UNITED STATES
NUCLEAR REGULATORY COMMISSION
WASHINGTON, D. C. 20555

ENCLOSURE 2

SAFETY EVALUATION OF THE REQUEST TO OPERATE
THE SHOREHAM NUCLEAR POWER STATION AT 25% POWER
ACCIDENT EVALUATION

Figure 7 CRAC2 calculated probability of 5 rem whole body dose being exceeded at 2 miles from the plant -- wetwell venting scenario

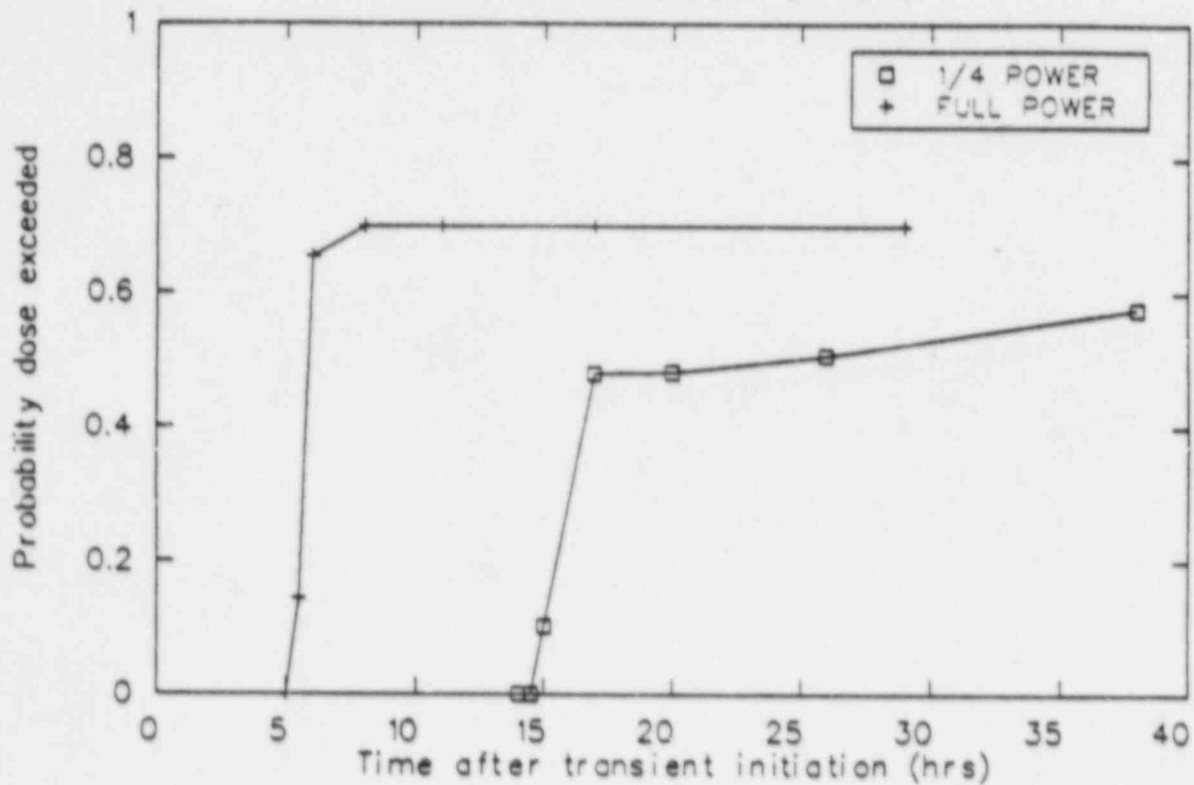
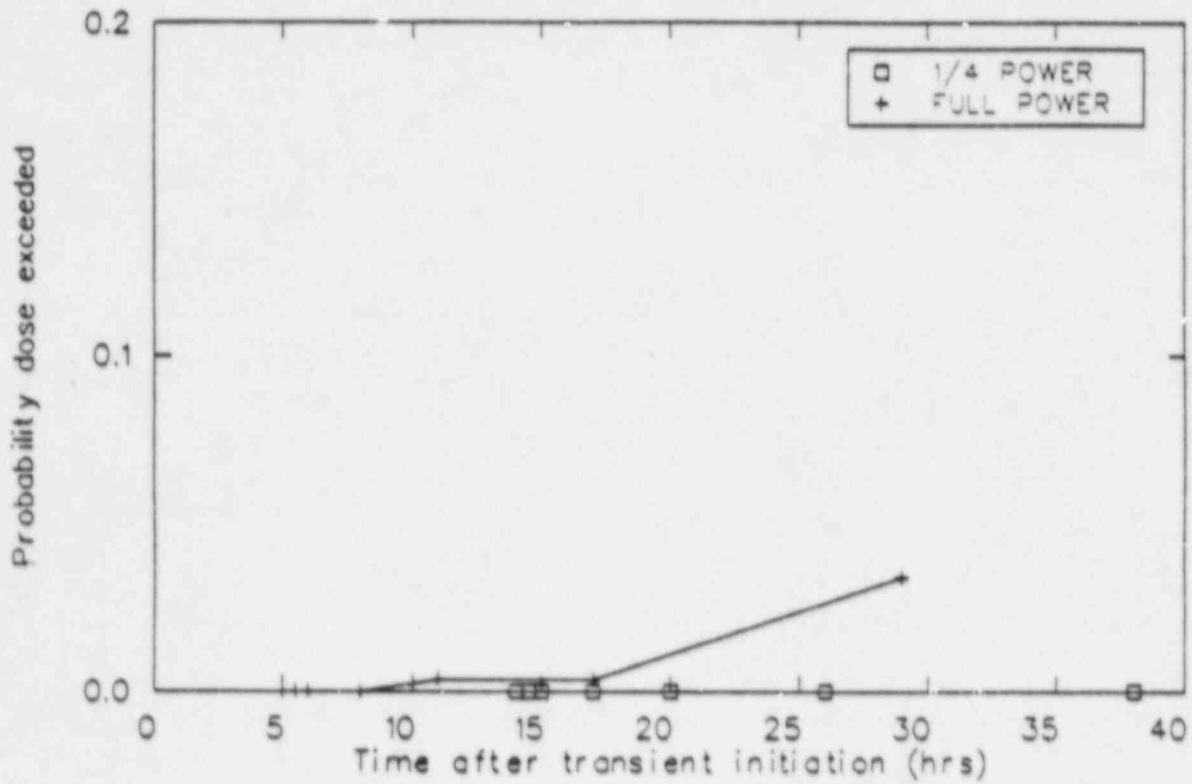
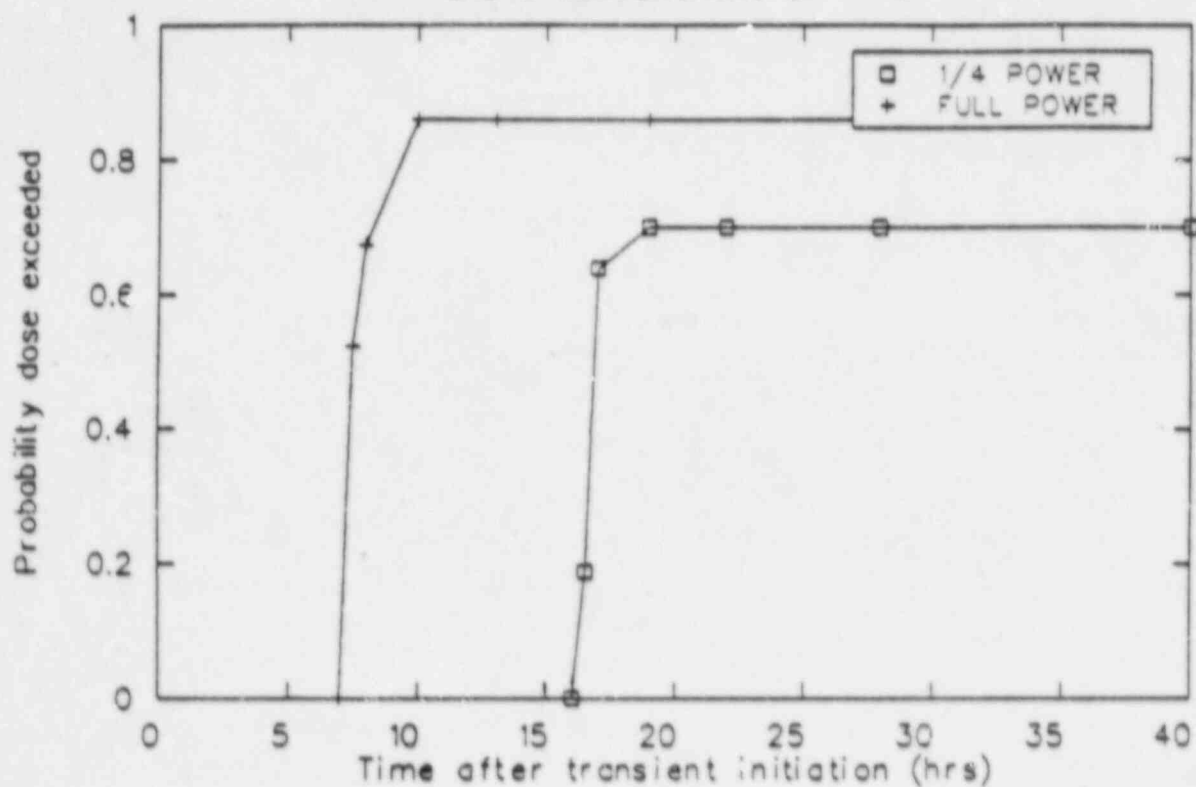
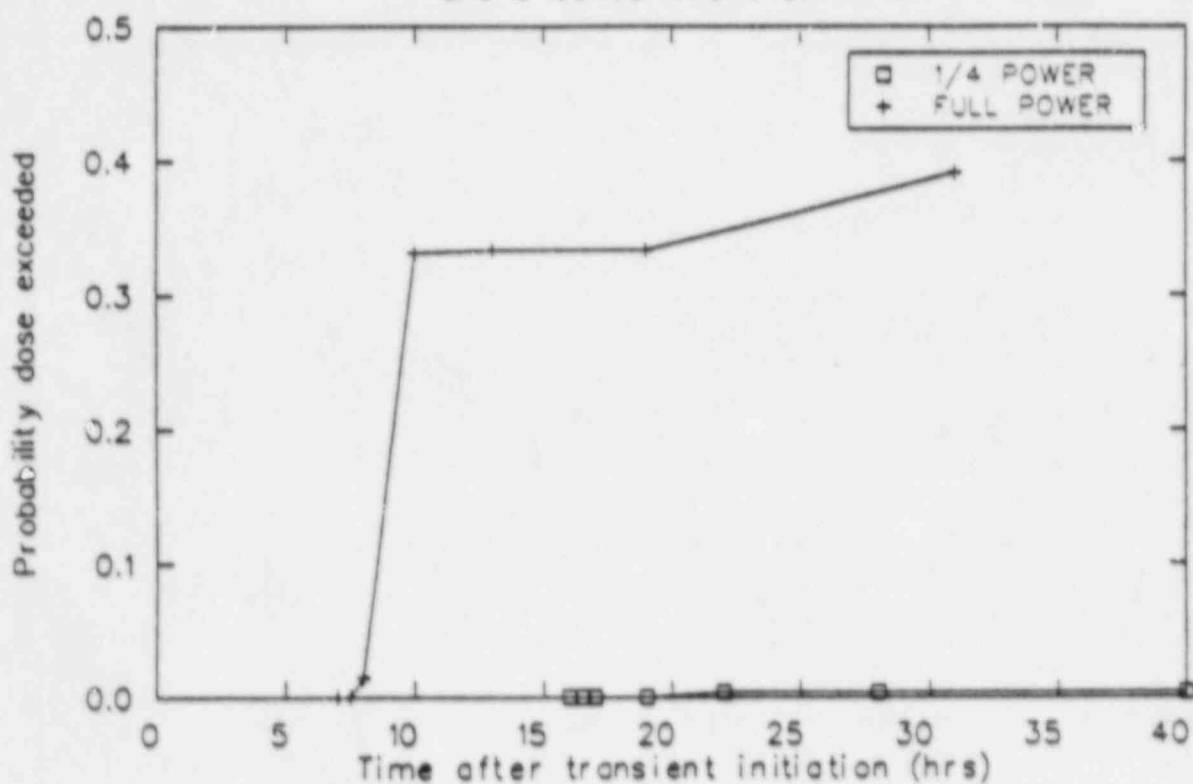
To provide some perspective as to the additional time for protective actions afforded by operation at 25 percent power, dose-versus-time probability figures were also generated. Figures 7 and 8 show the probability of five rem and 200 rem whole-body doses being exceeded at two miles versus time for the wetwell venting scenario at 25 percent and 100 percent power. Results for the scenario

Figure 11 CRAC2 calculated dose-versus-distance probability distributions for whole body dose of 5 rem -- early release scenario

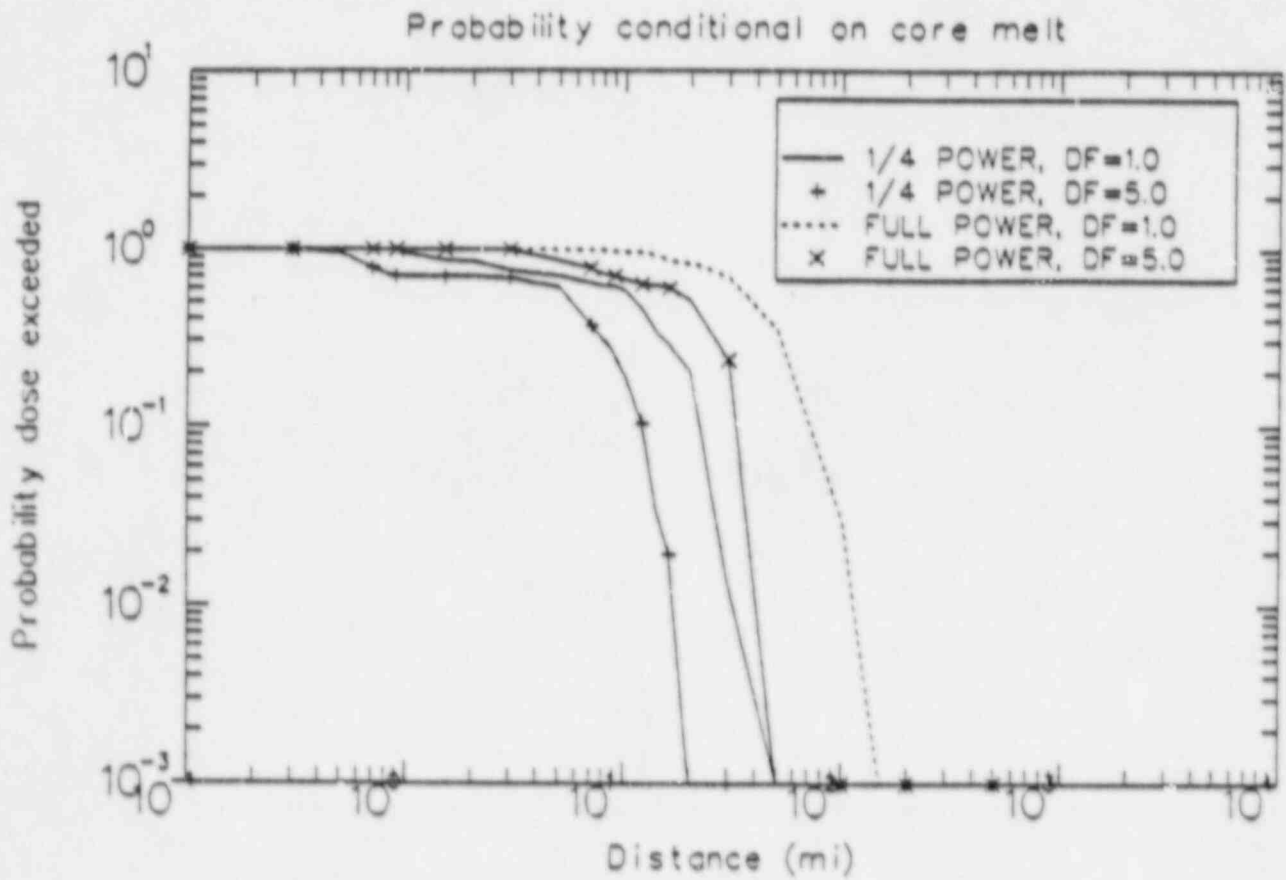
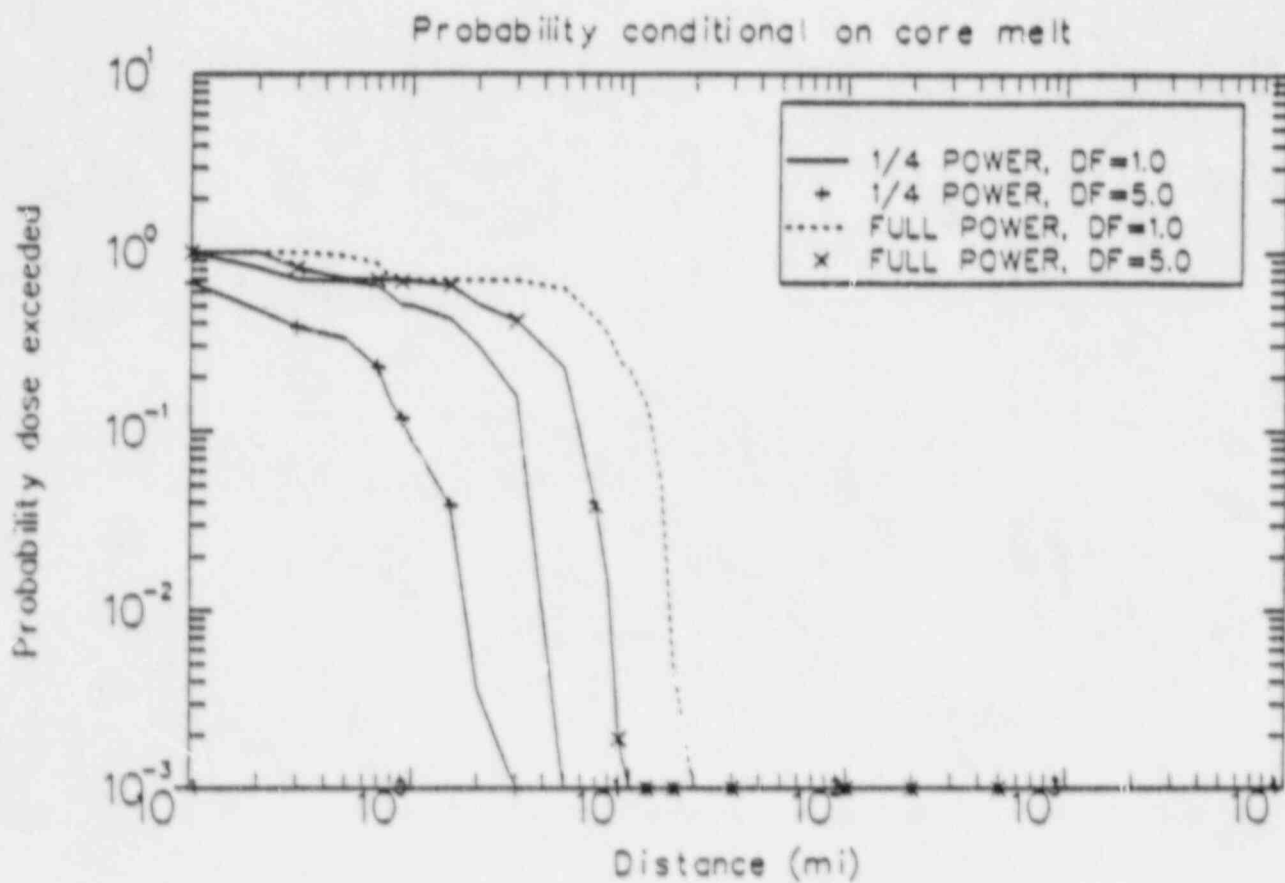
Based on the staff-developed source term, offsite consequence calculations were performed for operation at 25 percent and 100 percent power using the CRAC2 code. Table 17 lists the release fractions used in these calculations. Figures 11 and 12 show the five and 200 rem dose-versus-distance results for the various cases. As expected, the staff's dose-versus-distance probabilities were higher than those reported by LILCO. Also, the same general trends described in the previous section for slowly evolving transients can be observed here, specifically, that reducing the reactor power from 100 percent to 25 percent represents a significant reduction in the probability of exceeding a given dose, or conversely, a significant reduction in the distance over which a given dose would be exceeded.

Figure 13 CRAC2 calculated probability of 5 rem whole body dose being exceeded at 2 miles from the plant -- early release scenario

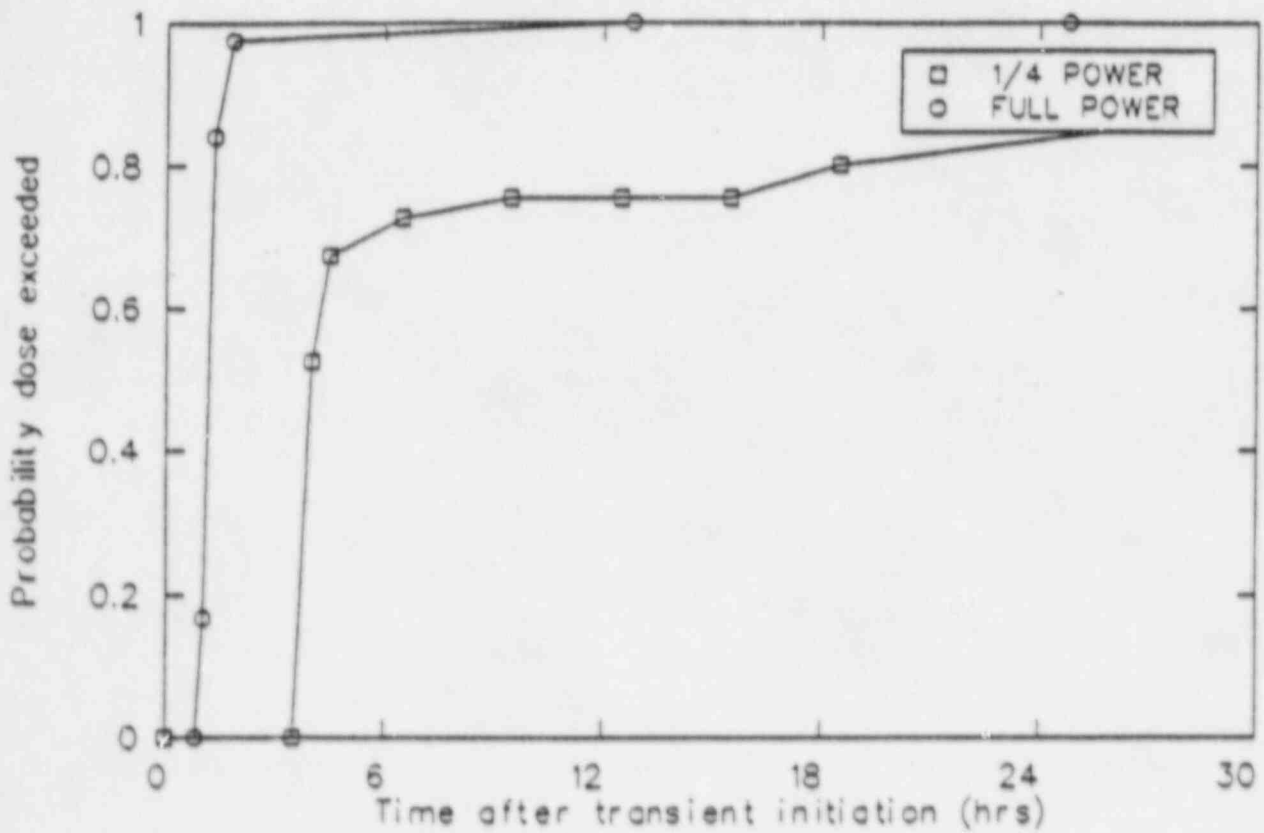
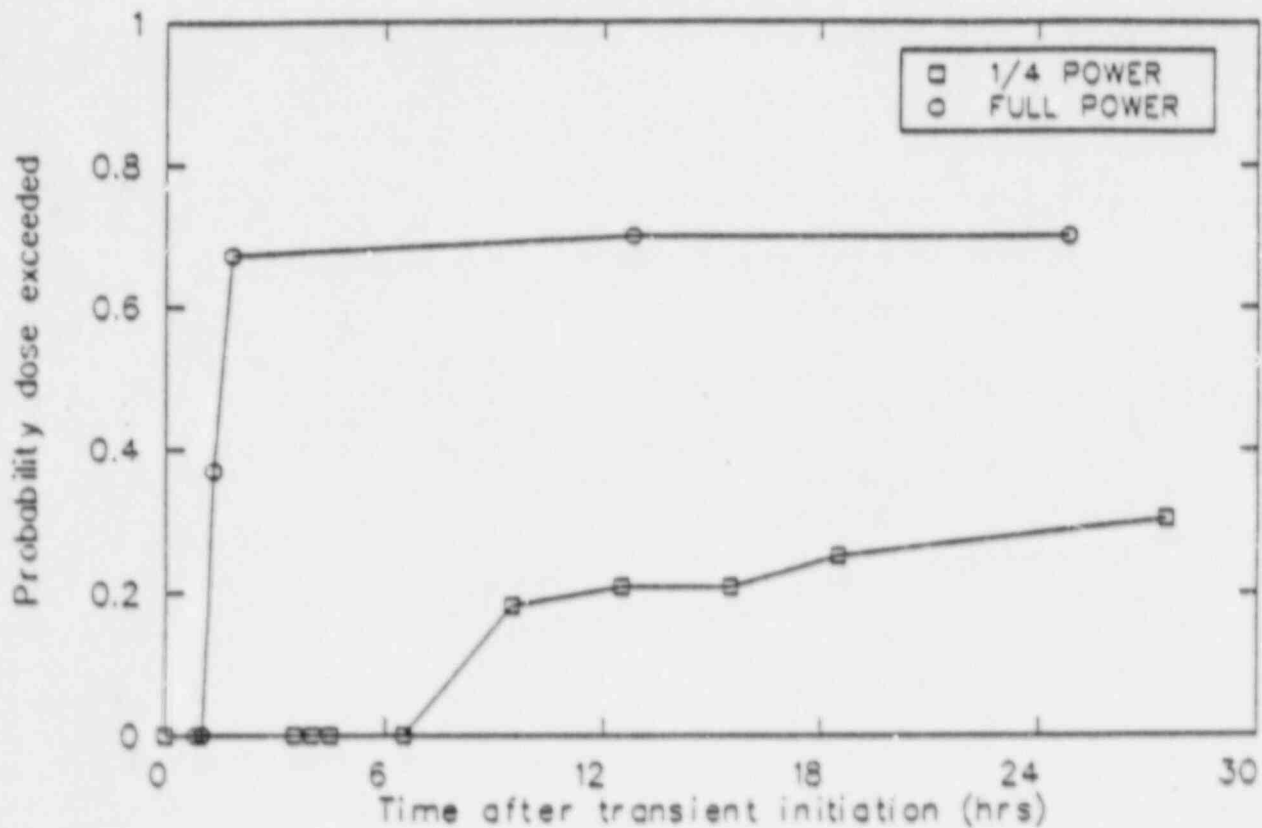
To provide some perspective as to the additional time for protective actions afforded by operation at 25 percent power, a set of dose-versus-time release conditional probability figures were generated following the procedure described in Section 4.2.2. Figures 13 and 14 show the probability of five and 200 rem whole-body doses being exceeded at two miles versus time for 25 percent and 100 percent power. The probability of exceeding the five rem dose two miles from the reactor approaches the 24-hour value quite rapidly for both 25 percent and 100 percent power, and the difference in the time required to reach a given probability of exceedance is comparable to the differences in the time to release for the 25 percent and 100 percent power cases. For the 200 rem doses, the results for full power indicate that following the time of release (0.8 hours) the probability of exceedance at two miles rapidly approaches its 24-hour value. For 25 percent power, CRAC2 indicates a much lower dose accumulation rate; specifically, 200 rem doses are not exceeded until about three hours after the time of release (3.5 hours) or six hours after transient initiation. Since there is a significantly shorter time to release for 100 percent power and a high probability that a 200 rem whole-body dose will be exceeded very shortly after the release, less dose savings could be realized for 100 percent power operation.
